POWER BUILDING

Re: Catawba Nuclear Station
Docket Nos. 50-413 and 50-414

In order to facilitate the completion of the review of the Catawba FSAR, Duke Power Company is transmitting herewith responses, revised responses, or partial responses to the following FSAR questions:

SPENT FUEL POOL
TEMPERATURE VERSUS TIME
CATAWBA NUCLEAR STATION
Figure Q410.12-1

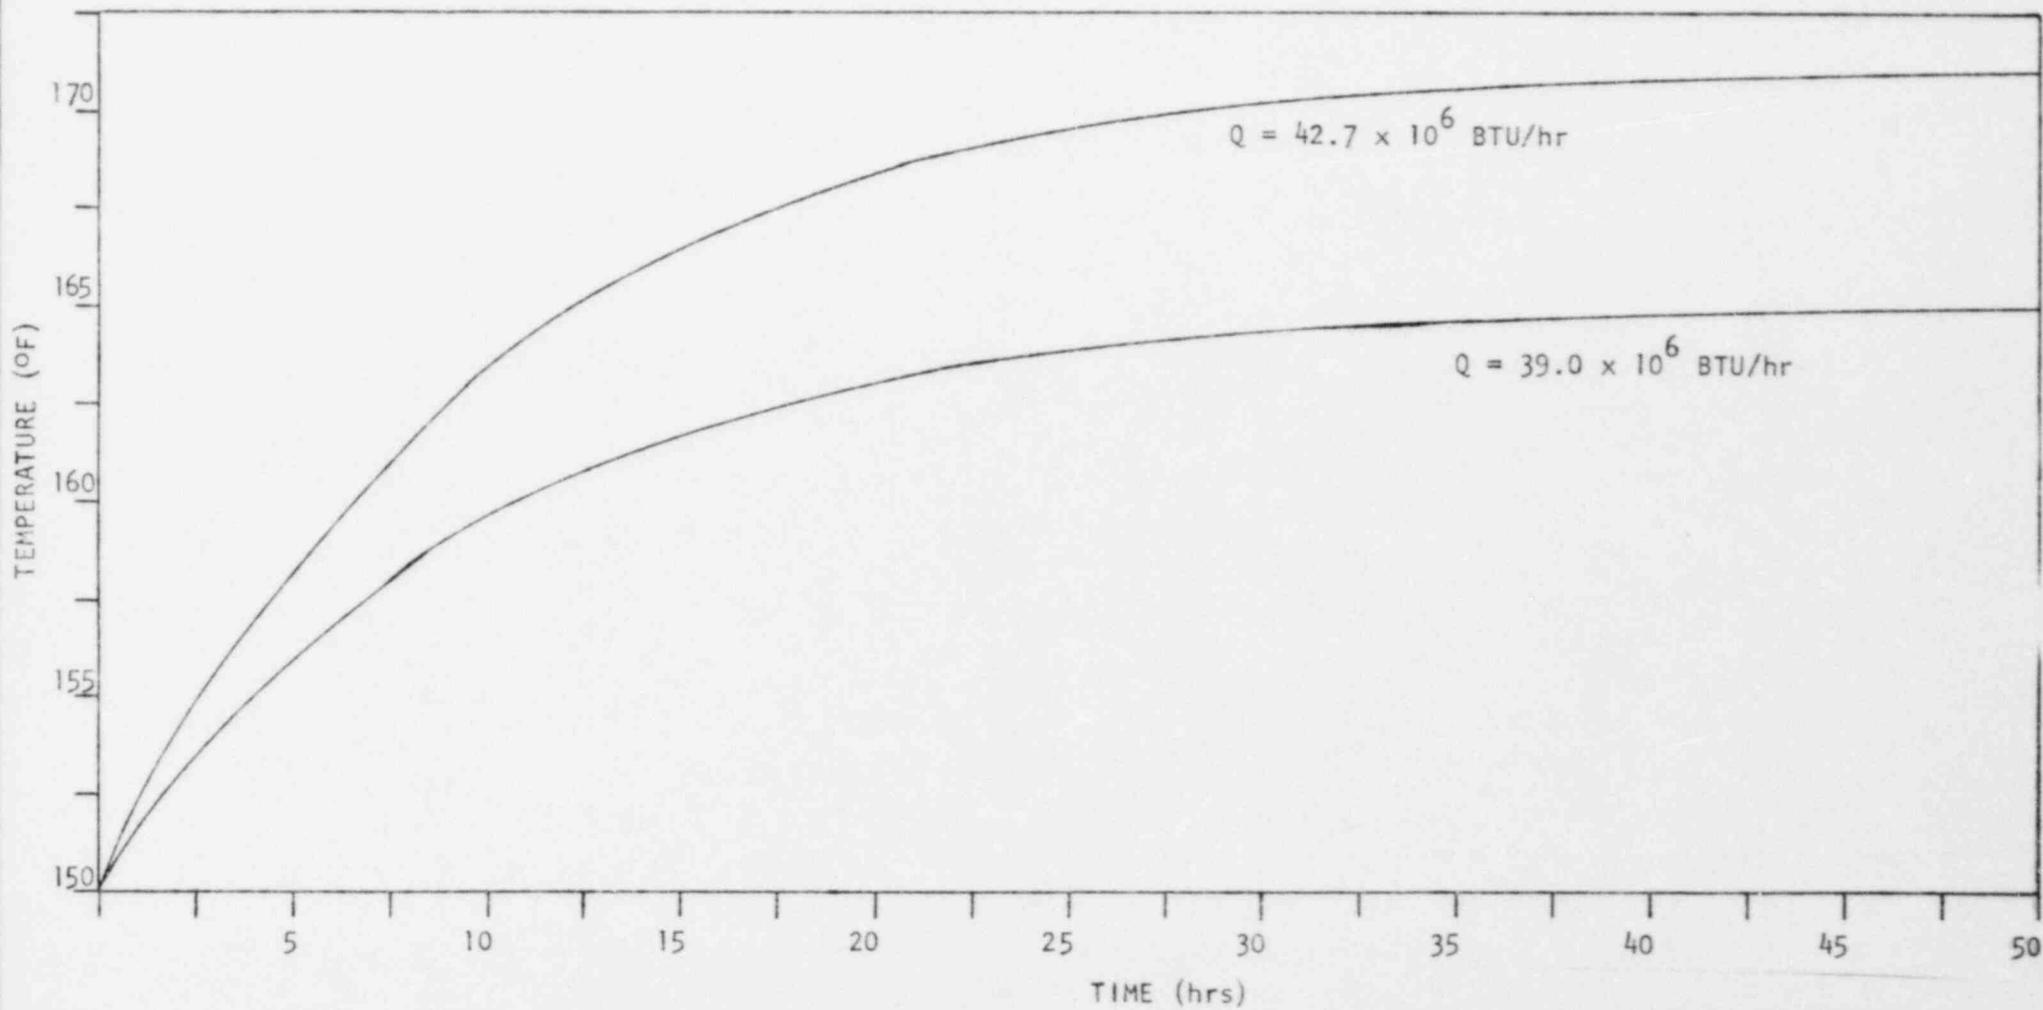
Provide information on the spent fuel pool water temperature following the loss of one cooling train assuming the maximum heat load condition with Catawba fuel and with non-Catawba fuel. Present an analysis of temperature vs. time for these two conditions. Describe

the disposition of the heat load to all heat sinks including the spent fuel pool heat exchanger, the spent fuel pool water purification system, any waste or drains, and the environment of the fuel building. Discuss the effects of the heat and humidity load on the fuel building ventilation system.

An analysis of temperature versus time for $Q = 39.0 \times 10^6$ BTU/hr (Catawba fuel) and $Q = 42.7 \times 10^6$ BTU/hr (non-Catawba fuel) was performed using only one spent fuel pool heat exchanger and the pool water as heat sinks. The results of this analysis are presented in Figure Q410.12-1.

The additional heat and humidity load for these two cases would not affect the fuel building ventilation system.
